JOINT AREA COMMITTEES IN SOUTH SOMERSET

Officer Report on Planning Application

07/03404/LBC

Proposal :	Conversion of redundant farm buildings (Unit A) into 2 no. residential units with associated B1 workshop (unit B) (GR 340950/115254)
Site Address:	Pond Farm Seavington St Michael Ilminster
Parish:	Seavington St Michael
SOUTH PETHERTON Ward (SSDC Member)	Paull Robathan (Cllr) Keith Ronaldson (Cllr)
Division (SCC Member)	Anne Larpent (Cllr)
Recommending Case Officer:	John Millar Tel: (01935) 462465 Email: john.millar@southsomerset.gov.uk
Target date :	26th December 2007
Applicant :	Mr & Mrs B Paull
Agent:	J D Thomas 33 Fairway Rise Chard, Somerset TA20 1NT
Application Type :	Other LBC Alteration

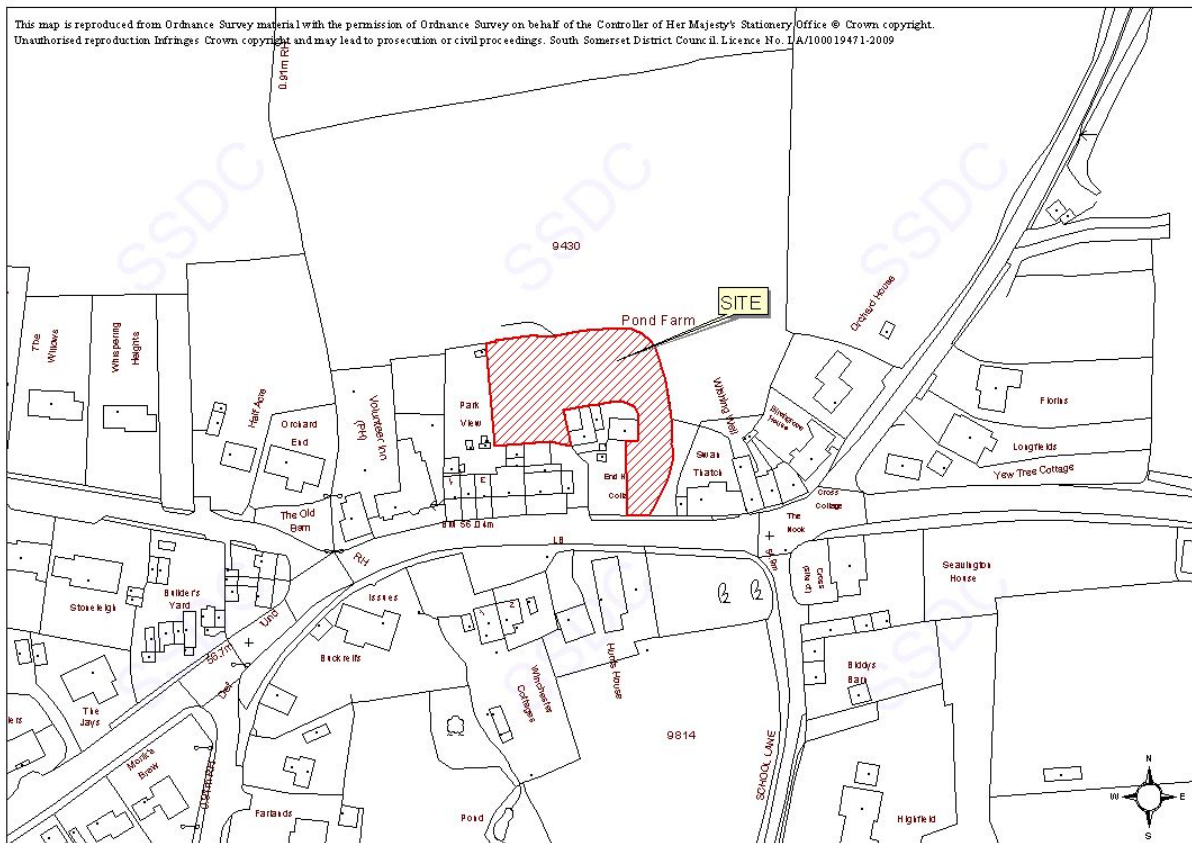
27th December 2007: The first point I would like to bring to your attention is that the visibility splays shown on the block plan are not indicated on the location plan.

The access to the site does cause me concern. The roadside wall is currently in poor condition, but is clearly of high quality. I am concerned that if it is demolished and rebuilt, any builder will struggle to rebuild it to the same quality and to this end, if consent is granted, I would require a sample panel of this roadside wall to be built, which would seek to mimic the existing high quality wall.

I find the provision of the splays in themselves a somewhat balanced issue and do have concerns that if the wall is demolished and rebuilt on the line shown for the splays along with this 4 1/2 metre, presumably tarmac, road running from it, that it will be damaging to the setting of the listed buildings and the street scene in general. At present the walls on this side of the road have a very linear flow and have very little punctuation in them, except at the public house. I am concerned that this combination of splay and wide access would be damaging to the area in general and the setting of the listed buildings. There may be some room for improvement by the provision of gate pillars and the immediate reduction in width of the roadway to a single track once within the site, but these matters in themselves do not reduce my concerns. I am also concerned that this access way through the site is inappropriate development.

4th March 2009: The proposal goes a little way to addressing my concerns, but I still remain concerned about the need for a 4 1/2 metre access both on to the road and through the site and the fact that the wall to the east is set back from the road.

If you are minded to agree an access at this point, I would seek at the very least to see that the access is narrowed and that the wall on the west side mirrors that on the east side. The access through the site should also be minimum width if possible perhaps with the odd passing place.

3rd November 2009: I am happy with the proposals as revised.
